1822 Bank Street

URBAN DESIGN BRIEF - R3

April 3, 2025

RESPONSE TO URBAN DESIGN COMMENTS

VIEW FROM ABOVE NORTHWEST SHOWING 45 DEGREE ANGULAR PLANE

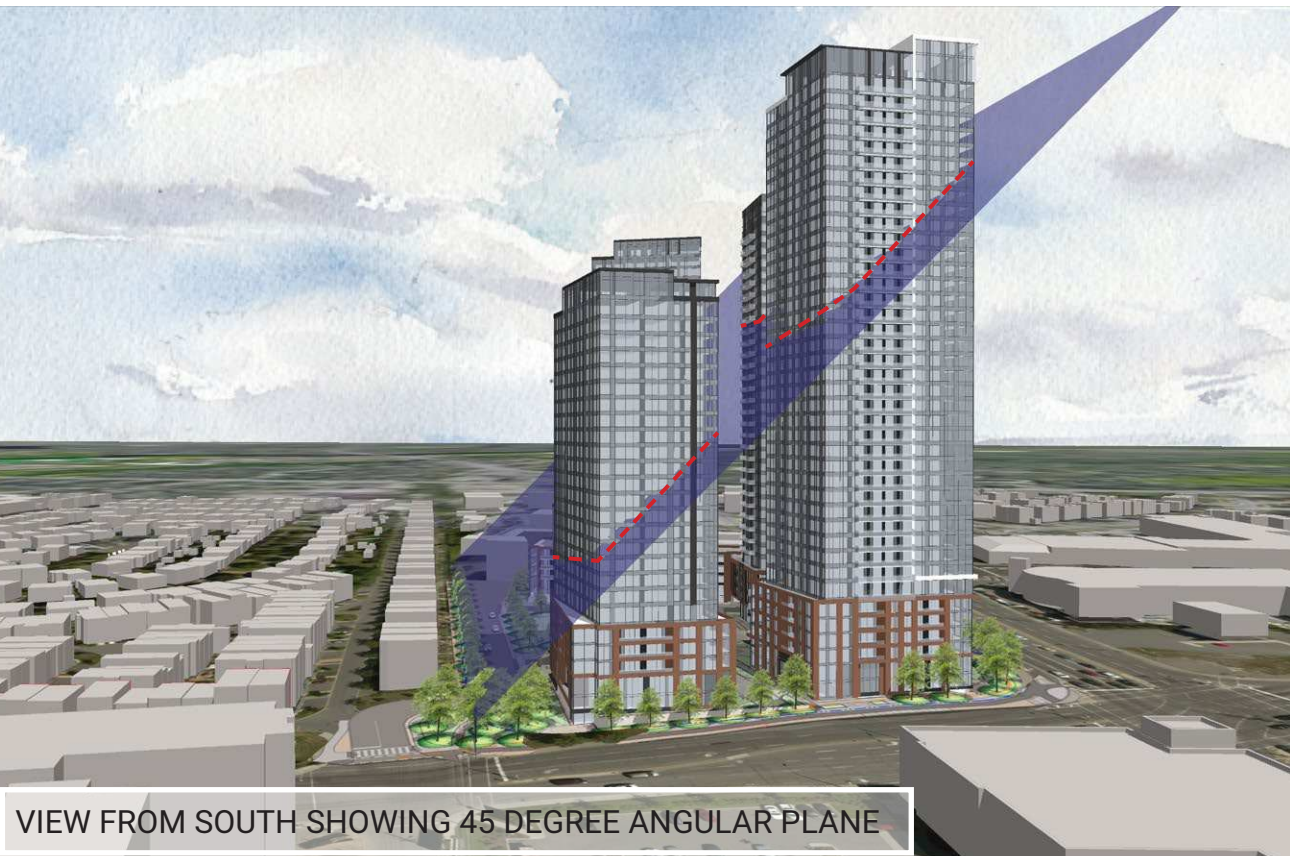
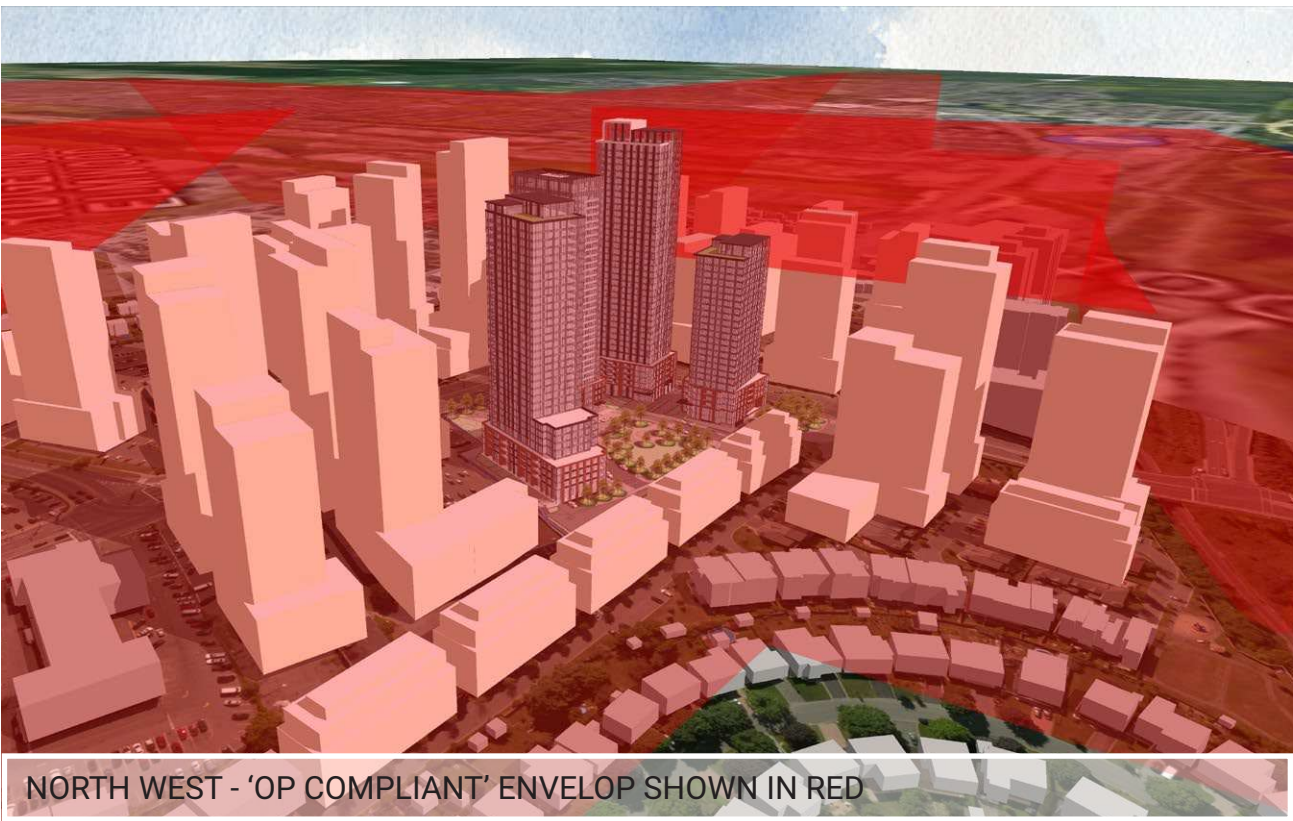
17. Towers 1 and 4 protrude significantly above the 45-degree angular planes as shown on page 20 of the submitted Design Package.
- i. Tower 1 – At the current proposed location and floorplate size, the height of the tower appears to be too tall.
 - ii. Tower 4 – The height should be reduced. It is interesting to note that if Tower 4 is a 16-storey building, permitted by the Secondary Plan, it will not protrude above the angular plane.

28. Slide 20 of the Design Package demonstrates the buildings projecting above the angular plane. While the angular plane is not meant to be a rigid determination of heights, it does inform the general appropriateness of building heights. In this case, it seems to me that Building 4 should be reduced by several storeys. In addition to improving the building height transition, this would add more variation to the building heights.

Applicant: We acknowledge that towers 1 and 4 protude through the angular plane. However we feel that this massing response is reason given the significant adjacent open space gained by locating the park at the west side of the property closest to adjacent low-rise. The park location serves to balance the impacts of the taller building forms. Additional, building 1 is the closest of the buildings to the new transit station, and therefore an appropriate location for a taller / higher density form.
